SUBJECT: OYSTER CREEK NUCLEAR GENERATING STATION  
WATER QUALITY CERTIFICATION

Oyster Creek Power Plant - Questions

SUBJECT Jersey Central Power and Light, Oyster Creek and Forked River Nuclear Power Plants

SUBJECT: FOPKED RIVER NUCLEAR STATION UNIT 1  
OYSTER CREEK NUCLEAR STATION UNIT 1  
STATE OF NEW JERSEY  
WATER QUALITY CERTIFICATE

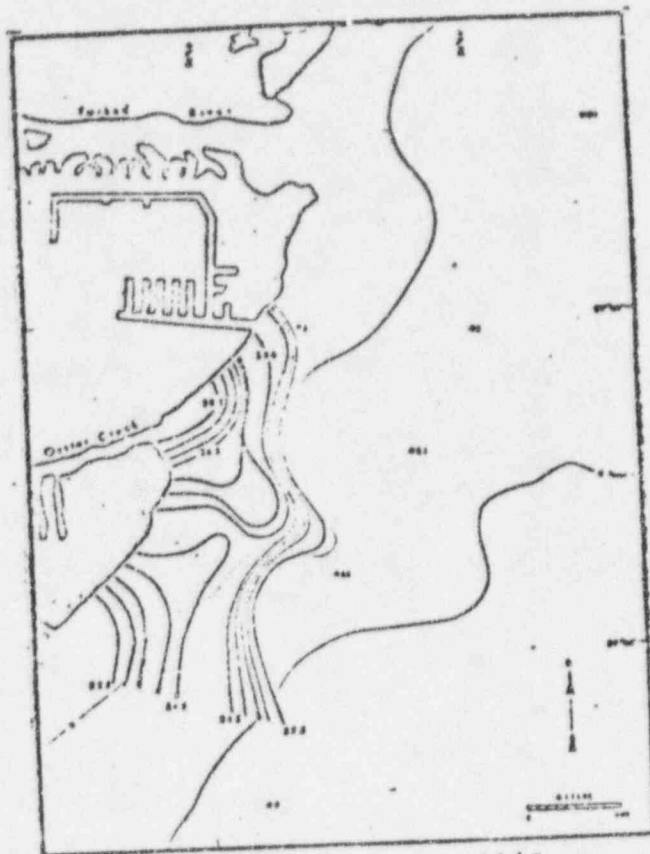
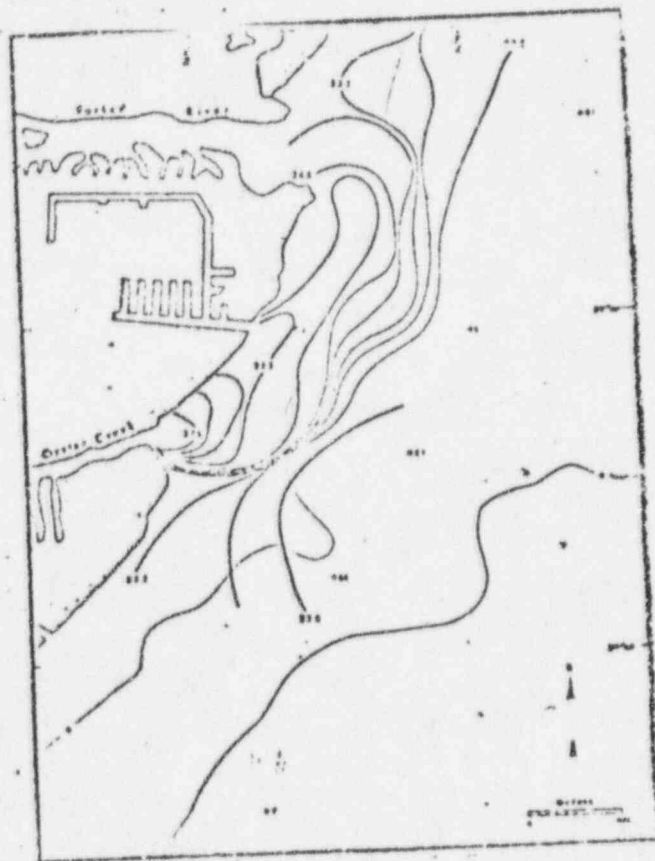
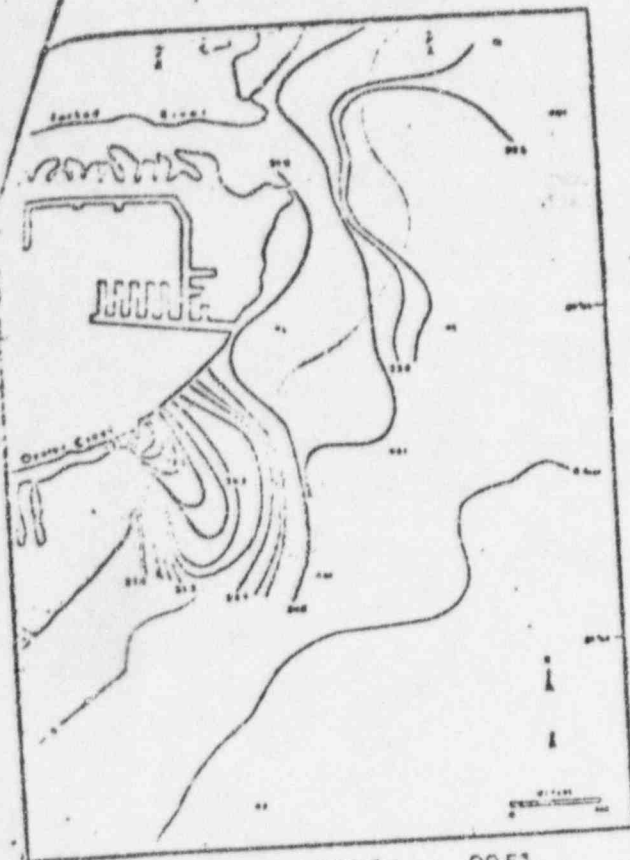
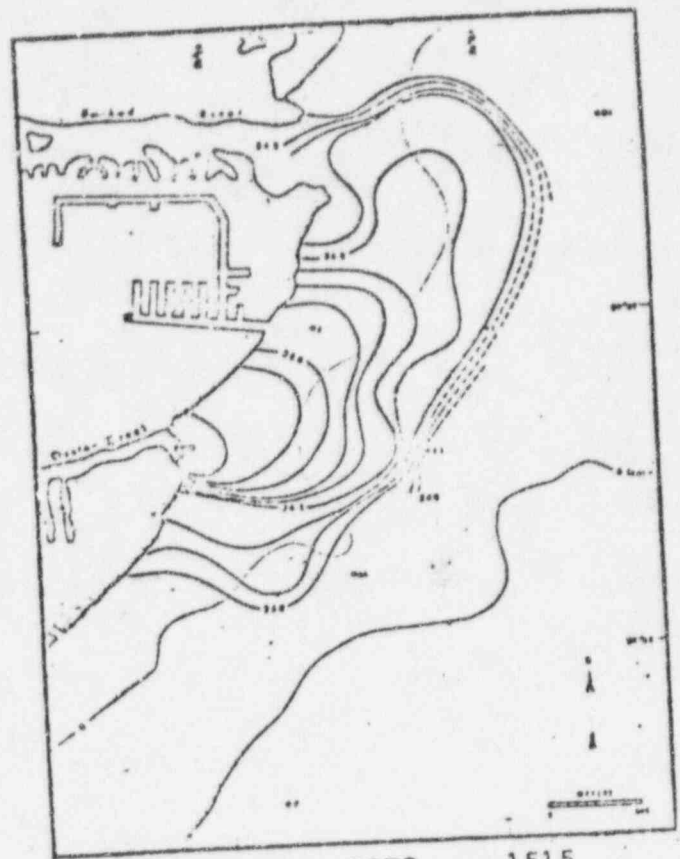
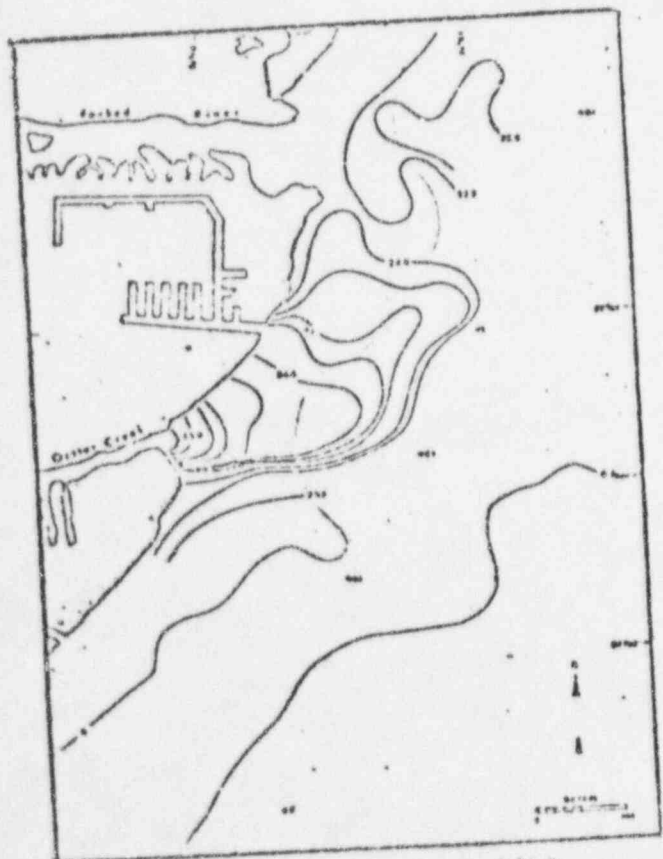
2. An analysis of the existing thermal discharge to Barnegat Bay including:
- a. Heat load evaluation under most stringent conditions with qualitative data, preferably expressed as isotherms, at various tidal cycles.
  - b. Submit data gathered at existing temperature monitoring stations utilized by the company.
  - c. Submit data on actual thermal dispersion pattern from the Oyster Creek facility.

- a. The maximum heat load from the Oyster Creek Plant is  $4.6 \times 10^9$  Btu/hr at full power (1930 MWt). Attached are figures of the Oyster Creek thermal discharge plume from the Sandy Hook Sport Fisheries Marine Laboratory.\* These figures depict all the data collected by the Sandy Hook Laboratory in 1970 and 1971.
- b. Table 2-1 indicates the Oyster Creek operating data, circulating water temperatures, and the Route 9 bridge temperatures corresponding to the plumes indicated in the figures. Figure 2-1 indicates the highest temperatures of each day from JCP&L's marker buoy "J" recorder in Barnegat Bay.
- c. See the Sandy Hook Marine Laboratory figures included in the response to Question 2.a.

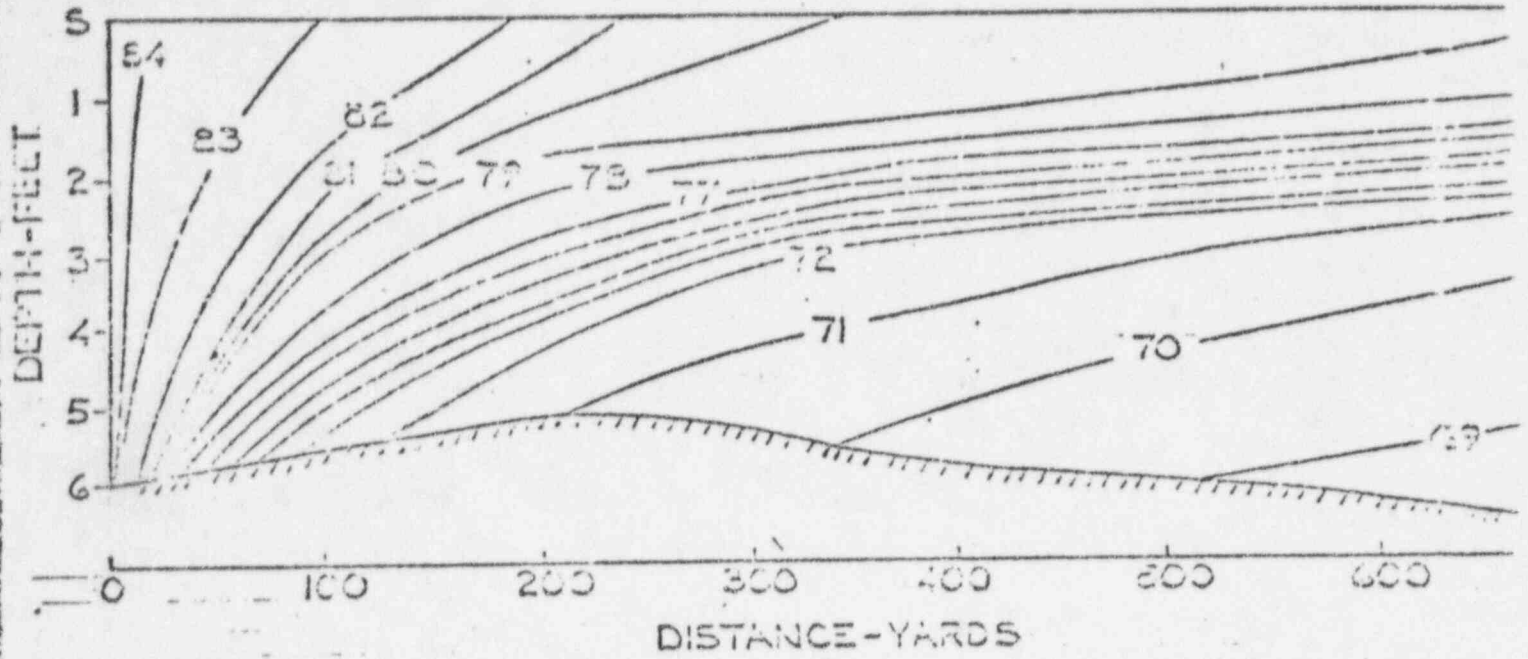
1. Locate and describe (horizontal and vertical) the water area that will have temperatures in excess of 85° F. as a result of discharges from the Oyster Creek Power Plant.

The vertical distribution of waters with temperatures greater than 85° F. or 87° F. appears to be the upper three feet except in an area extending approximately 100 yards from the mouth of Oyster Creek. The attached Figure 1-1 is a plot of data collected on June 7, 1970. The ambient Bay water temperature on this date was 68° F. Maximum ambient Bay water temperatures are approximately 80° F., so that 85° F. would be a 5° F. increment and 87° F. would be a 7° F. increment. As may be seen in Figure 1-1, a 5° F. increment or 73° F. was confined to the upper three feet except immediately off Oyster Creek entrance.

FIGURE 7-1

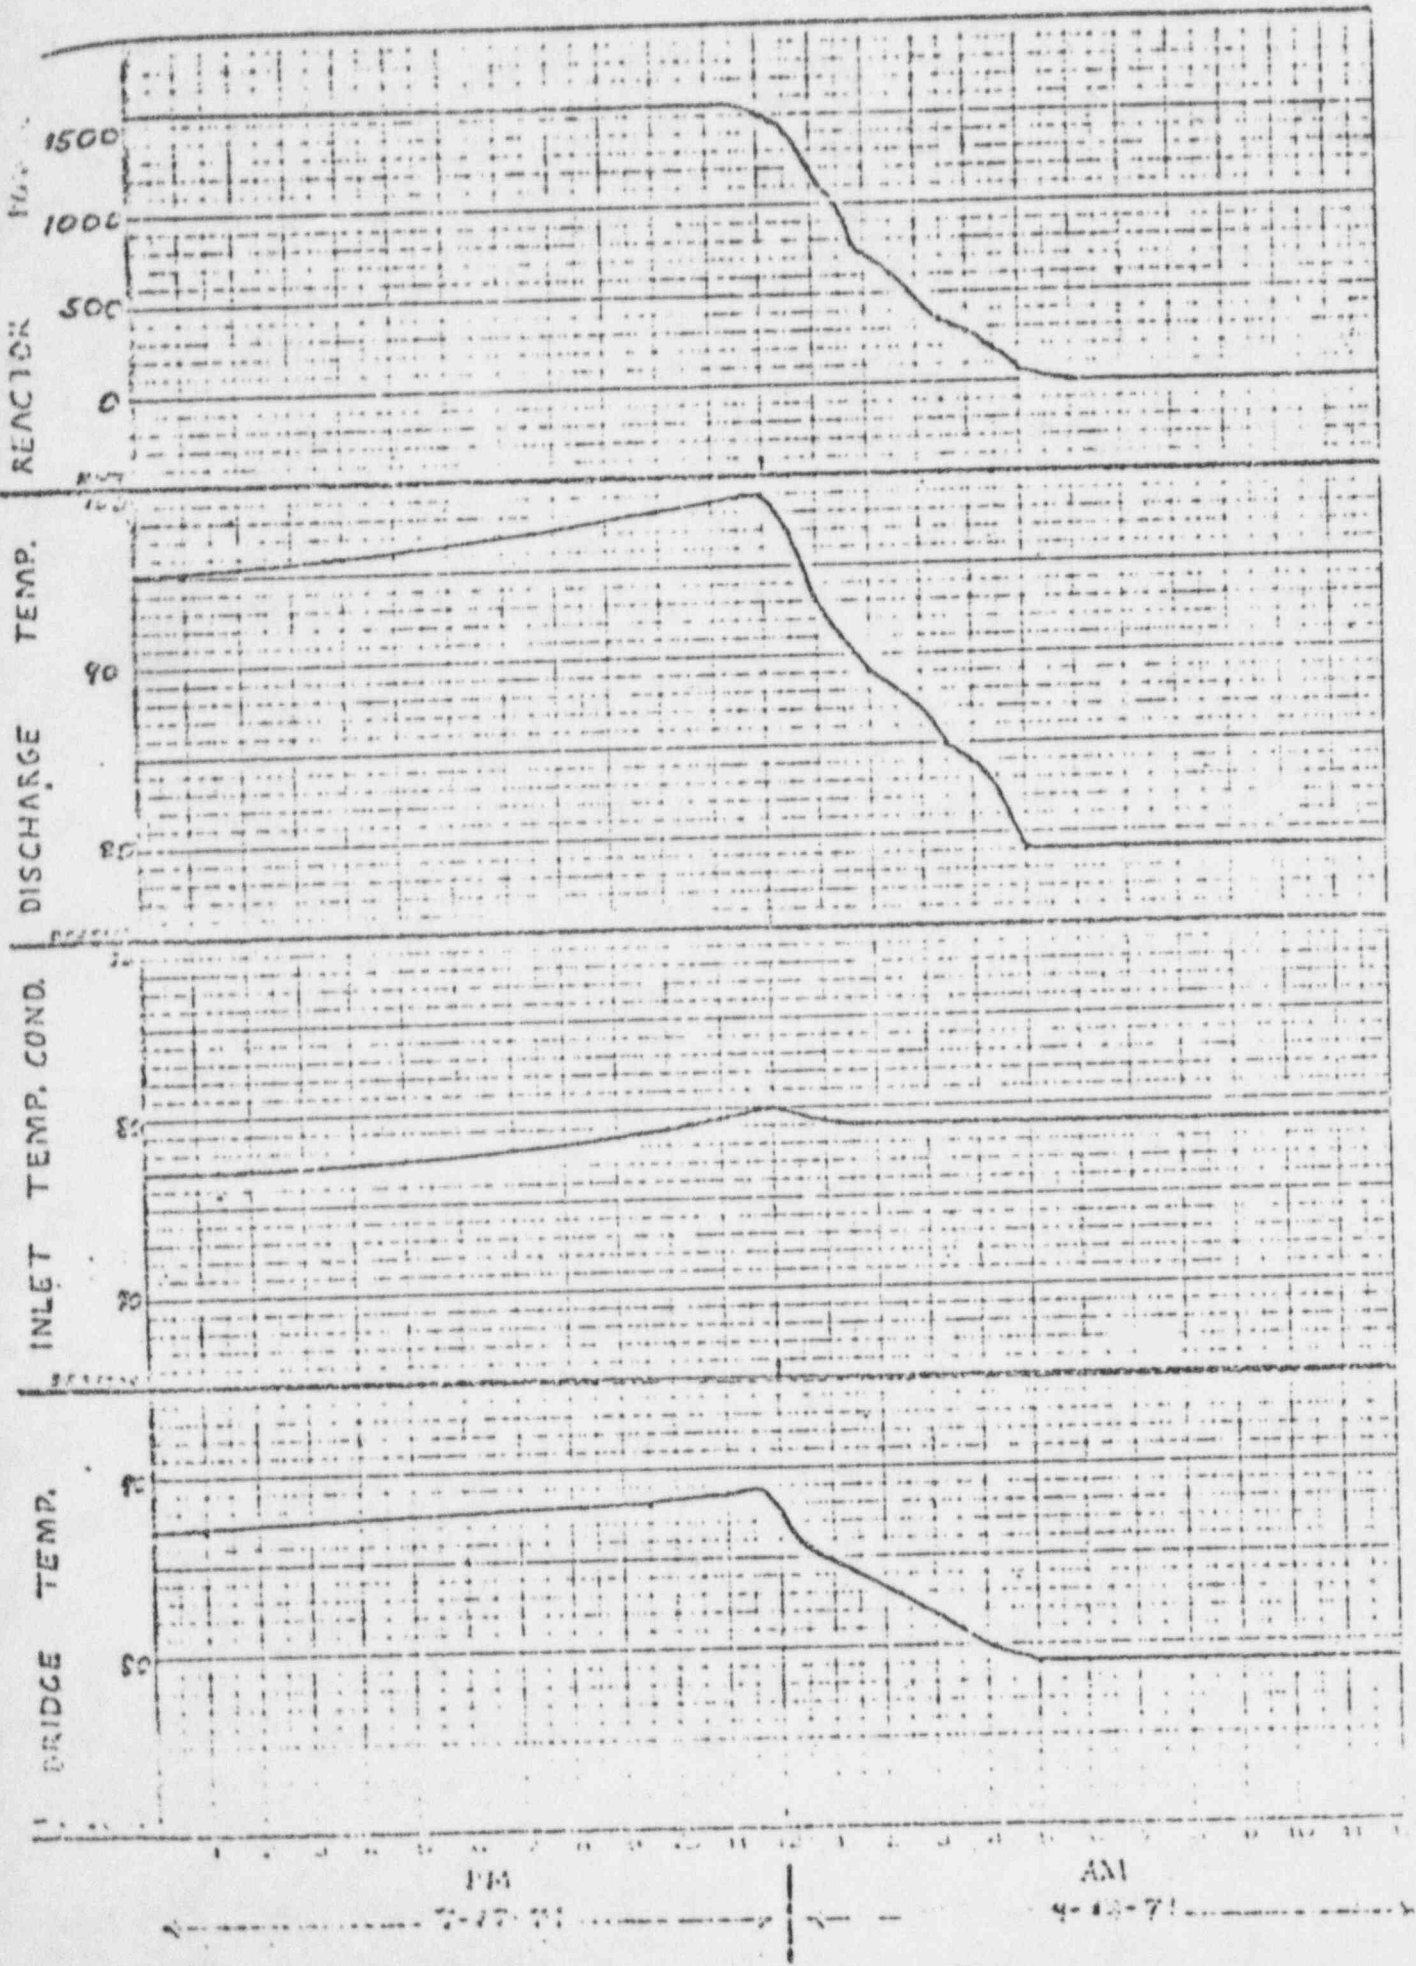
7. What are the range and rates of temperature decreases as the result of power plant slowdown, and what has been their effect upon fish and shellfish common to the area?

Based on information from the Oyster Creek Plant (See Table 7-1 and Figure 7-1), a typical plant shutdown results in a circulating water cooldown rate at the discharge canal Rt. 9 bridge (property line) of about  $1.82^{\circ}\text{F/hr.}$  The rate at the condenser outlet is greater (about  $4^{\circ}\text{F/hr.}$ ). These numbers are typical for the normal plant shutdowns and on the average one would expect 2-6 of these each year.
